Subject: WATER AND WASTEWATER CAPACITY AVAILABILITY LETTER

The Benjamin – DRC Case No. UDP-S22035 777 SE 3rd Avenue, Ft. Lauderdale, FL 33316

City of Fort Lauderdale Public Works Department Water and Wastewater Capacity Analysis

Figure 2 - City Sewer Atlas

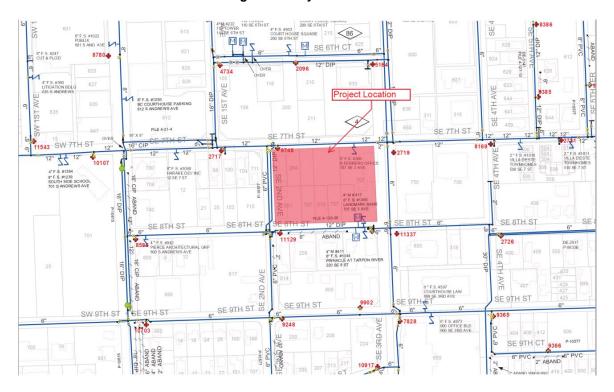
Wastewater: The site is currently served by a 10-inch gravity sewer main to the south of the project site along SE 8th Street. See Figure 2.

Evaluation of impact on existing collection pipe: According to the site plan, the applicant is proposing to utilize the 10-inch gravity sewer main to the south of the project site along SE 8th Street. The City uses a peak hourly flow factor of 3.0. Accounting for existing flows and based on the tools and information available to the City staff, it has been calculated that the pipes downstream of the proposed development will flow greater than the City's governance plan threshold of 70% during peak flows. Therefore, the pipes upstream of the pump station will need to be improved to serve the project's increased demand. See Figure 3. Any Certificate of Occupancy will not be issued until the sanitary sewer system improvements are fully implemented and functional.

Figure 3 - Required Sewer Improvements

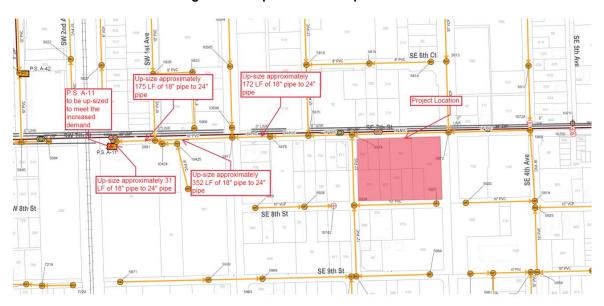
The sewer infrastructure requires improvements to meet the increased demand of the proposed project, see Figure 3. The proposed water infrastructure has the capacity to support the proposed development. Any Certificate of Occupancy will not be issued until the sanitary sewer system improvements are fully implemented and functional.

Evaluation of impact on pumping station: Currently, PS A-11 has a firm capacity of 1145 gallons per minute (GPM) and has a Nominal Average Pumping Operating Time (NAPOT) of approximately 9.07 hours per day. Based on projected sewage flows, the pumping run times would increase approximately 65 minutes per day. Additionally, there are other committed flows from proposed developments within the PS A-11 basin resulting in 260.24 minutes of additional runtime. PS A-11 will have a NAPOT of 14.48 hours once the proposed developments are complete, which exceeds the recommended average of 10 hours per day. Therefore, improvements to the pump station will need to be made in order to reduce the run times and meet the new demands. See Figure 5 below. Any Certificate of Occupancy will not be issued until the sanitary sewer system and the pump station improvements are fully implemented and functional.

Recommended Wastewater Infrastructure Improvements: Prior to issuance of a Certificate of Occupancy, approximately 730 LF of 18" to 24" pipe and upsizing of the pump station per Figure 3.

Figure 4

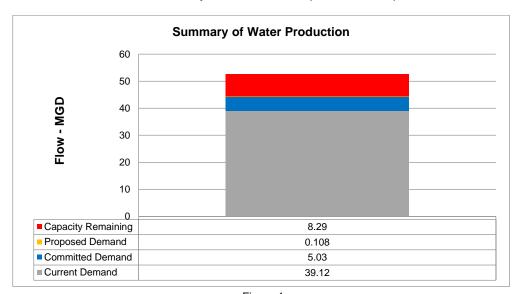
Evaluation of impact of Permitted Water Plant Capacity: The Fiveash and the Peele Dixie Water Treatment Plants are designed to treat 70 MGD and 12 MGD of raw water respectively (82 MGD total). The total permitted Biscayne aquifer water withdrawals for these plants is limited to 52.55 MGD per the South Florida Water Management District (SFWMD) permit number 06-00123-W.

The current twelve-month rolling average production at the two plants is 39.12 MGD. The previously committed demand from development projects in the permitting or the construction stage is 5.03 MGD. Combining these figures with the demand from the proposed project of 0.1076 MGD, the required production would be 44.26 MGD. This is less than the allowable withdrawal limit of 52.55 MGD. Therefore, the water plants have sufficient capacity to serve this project. See Figure 4 below.

Recommended Water Infrastructure Improvements: No improvements required.

Figure 6

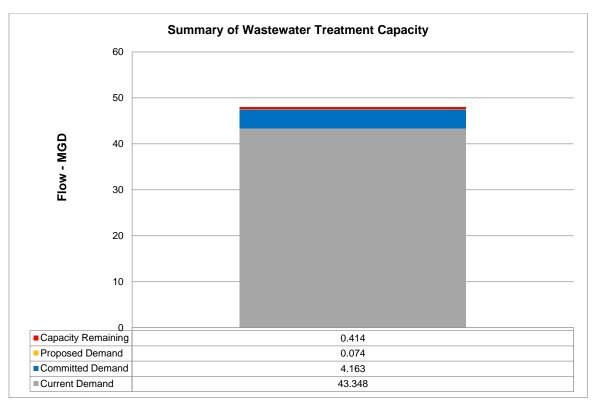
Evaluation of impact of Permitted Wastewater Plant Capacity: The City of Fort Lauderdale owns and operates the George T. Lohmeyer Regional Wastewater Treatment Plant (GTL), which provides wastewater treatment for the City of Fort Lauderdale. The Broward County's Environmental Protection and Growth Management Department's (EPGMD) Environmental Licensing & Building Permitting Division's licensed capacity for GTL is 48 MGD-AADF (Million Gallons per Day – Annual Average Daily Flow). The annual average daily flow (AADF) to the plant is 43.35 MGD. Combining the committed flows for previously approved projects of 4.16 MGD plus the 0.0741 MGD net contribution from the project results in a total projected flow of 47.58 MGD. This is less than the permitted treatment plant capacity of 48 MGD. Therefore, the treatment plant has sufficient capacity to serve this project. See Figure 6 below.
